SUBJECT: COMANCHE PEAK NUCLEAR POWER PLANT, UNITS 3 AND 4
DOCKET NUMBERS 52-034 AND 52-035
RESPONSE TO REQUEST FOR ADDITIONAL INFORMATION NO. 4760

RESPONSE TO REQUEST FOR ADDITIONAL INFORMATION

RAI NO.: 4760 (CP RAI #171)

SRP SECTION: 03.07.02 - Seismic System Analysis

Figure 1 – Comparison of Design Response Spectra to the UHSRS In-Structure Response Spectra at Basin Slab

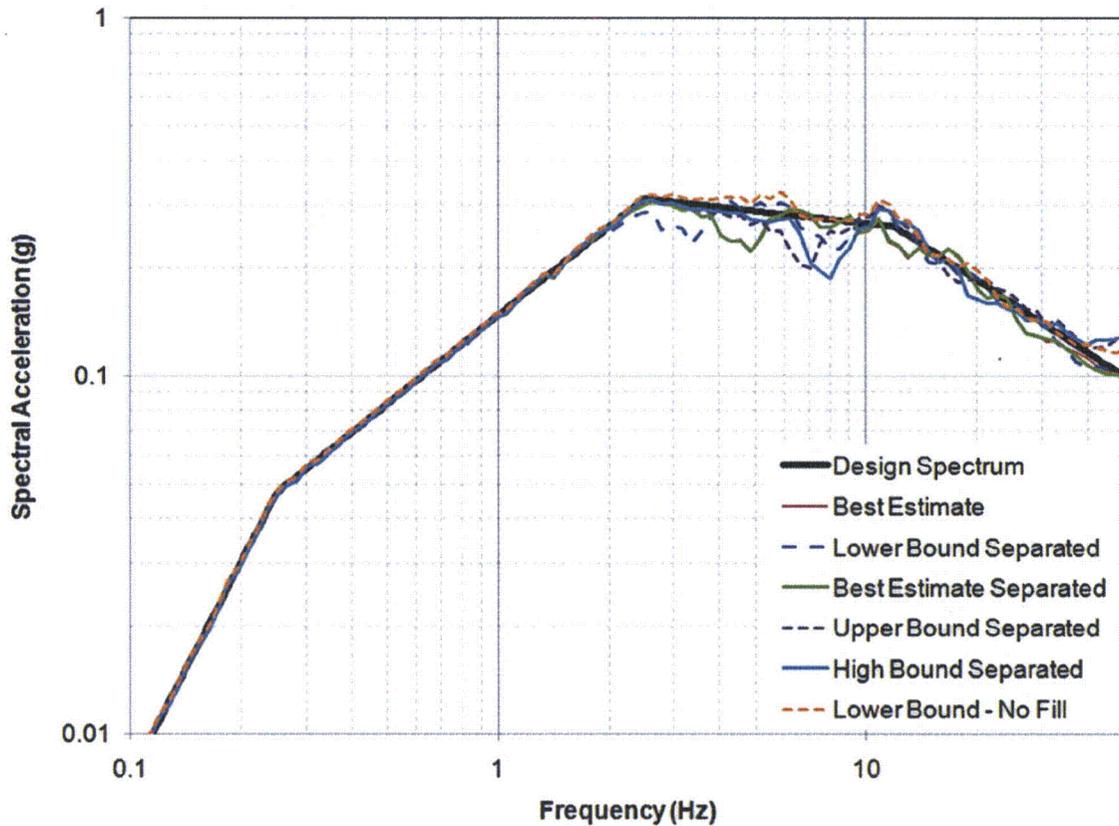
The applicant is requested to discuss the potential impact of the nearby slopes indicated in the site profiles on the computed SSI responses to ensure that the computed seismic responses will not be under-estimated at some frequencies of interest.

Specifically, the staff would like to know how the Squaw Creek Reservoir slope may affect the SSI analysis and the stability of Unit 3 ultimate heat sink (UHS) structures, which are located near the reservoir slope, as shown in FSAR Figure 2.1-201.

The results of the SSI analyses indicate that the SSI effects on the response of the UHSRS are not significant because the limestone layer upon which all UHSRS are founded is relatively stiff. Figure 1 below presents the in-structure response spectra (ISRS) obtained from the SSI analyses of the UHS basin foundation slab for the best estimate and lower bound no-fill cases and for the embedded cases (lower bound separated, best estimate separated, upper bound separated, and high bound separated), together with the horizontal input design response spectra. The ISRS are similar to the design input response spectra except that the results of the embedded foundation SSI analyses show reductions of the amplitudes at the backfill soil column frequencies where the backfill influences the rock in-layer response spectra, thus indicating that the SSI effects on the seismic response of the UHSRS are small. As a result, responses of the UHSRS are not considered to be sensitive to variations in the surface geometry or properties of the limestone due to the presence of the reservoir. Therefore, the presence of the reservoir slope does not impact the SSI results, and the use of a horizontally-infinite half-space and consideration of a broad range of embedment conditions ensures that the ISRS results envelope the actual site conditions.
